寄件者: cheung fennie <[REDACTED]>  
寄件日期: 2025年01月13日星期一 16:32  
收件者: Charlotte Tsz Wing WUN/PLAND  
主旨: 回覆: [A/NE-TK/800] - Comments from the Drainage Services Department  
附件: stormwater proposal 2nd submission to TPB (A\_NE-TK\_800).pdf  
類別: Internet Email

PROJECT TITLE:  
 STORMWATER DRAINAGE PROPOSAL FOR  
 TEMPORARY PRIVATE VEHICLE PARK (PRIVATE  
 CARS AND LIGHT GOODS VEHICLES ONLY) FOR  
 A PERIOD OF 3 YEARS AT VARIOUS LOT IN D.D. 26  
 AT SHUEN WAN CHIM UK, TAI PO

DRAWING TITLE:  
 DRAINAGE PROPOSAL PLAN  
 AND TYPICAL DETAILS

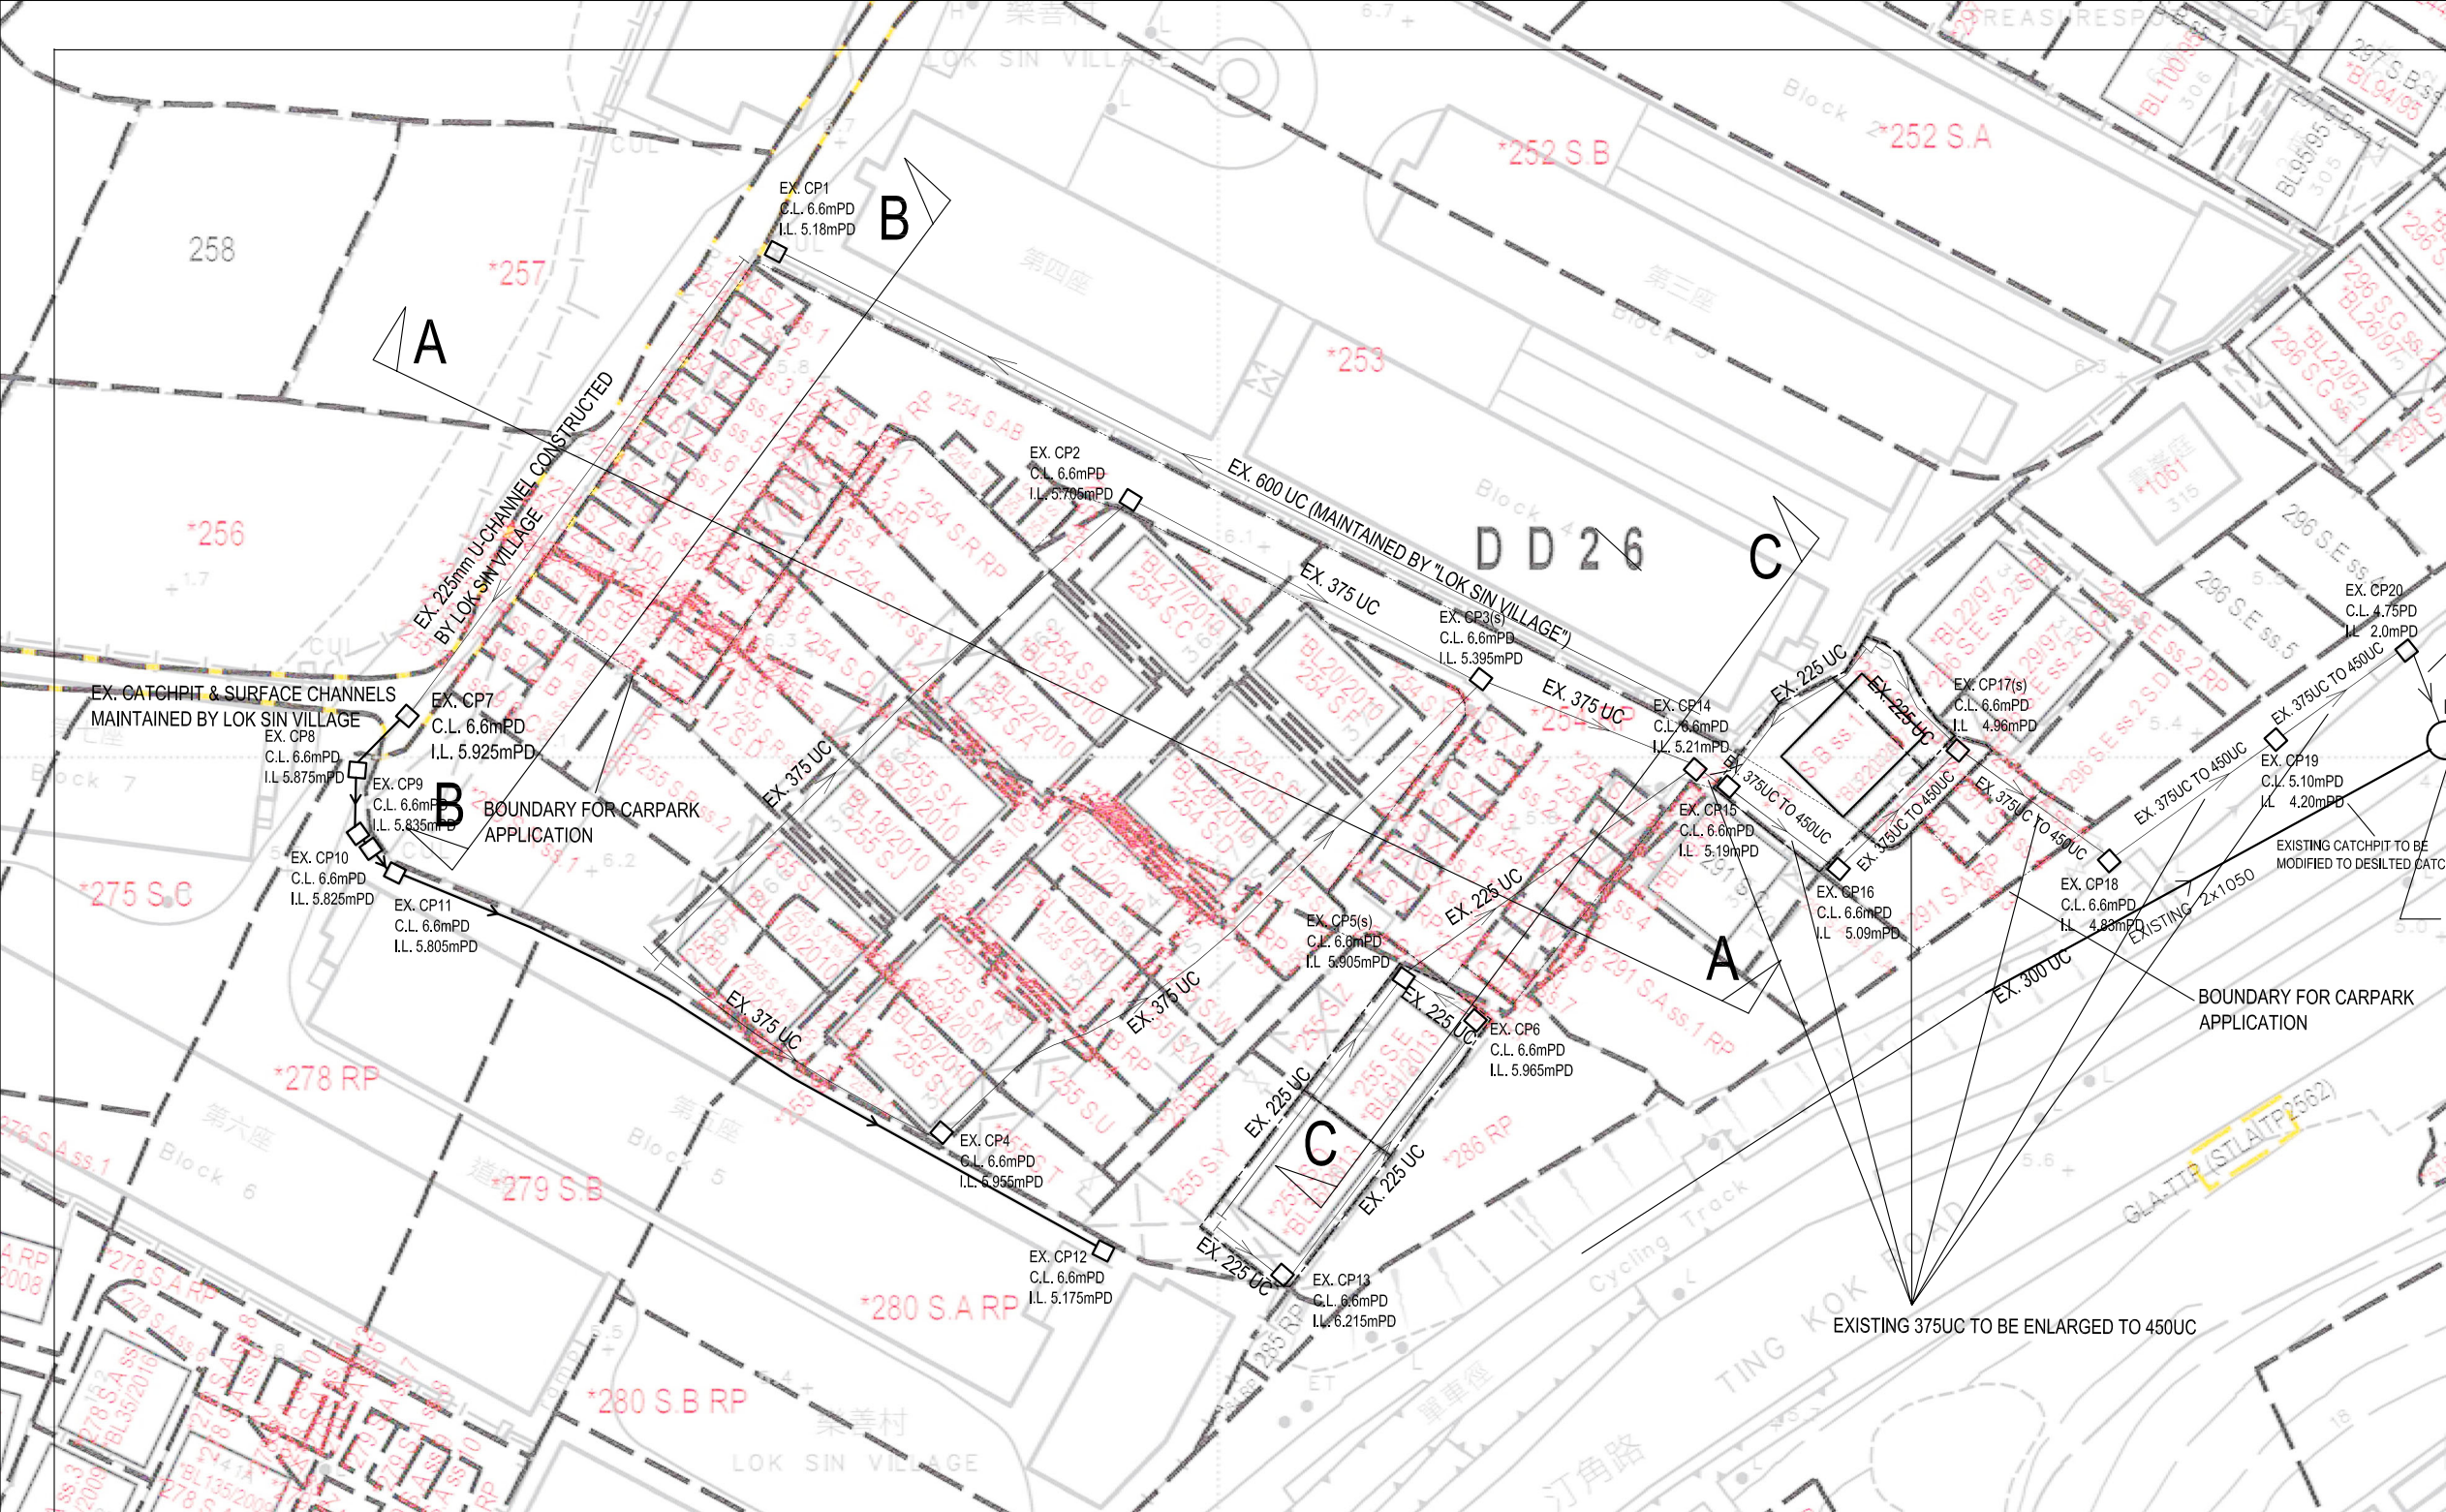
please find the below comments from the Drainage Services Department for your follow up action please:

Comments from the CE/MN, DSD (Contact Person: Karen HO, Tel: 2300 1364)

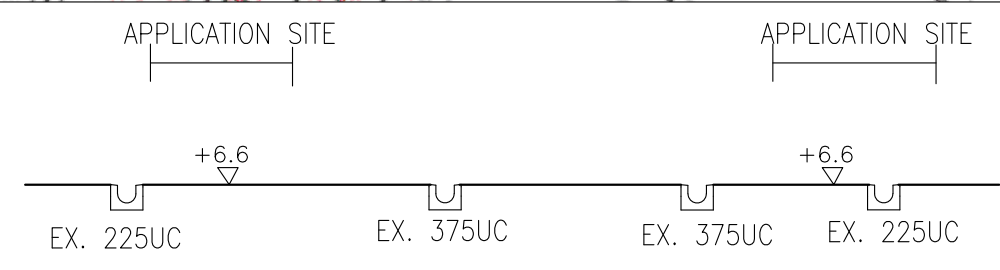
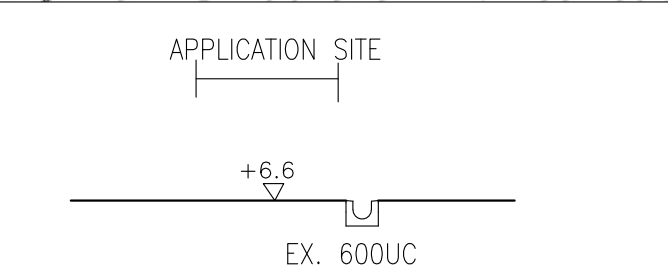
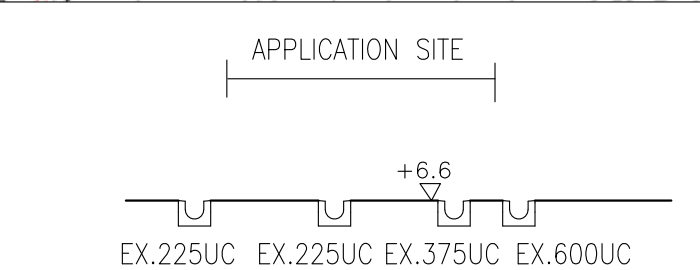
REV	DESCRIPTION	CHECKED	APPROVED	DWN	DATE
A	DSD'S COMMENT	RC	AY	RY	DEC 24
	DLO SUBMIT	RC	AY	RY	NOV 24

Check for the drainage capacity of existing 375UC

Maximum capacity = 13500 lit/min > 11871 o.k.
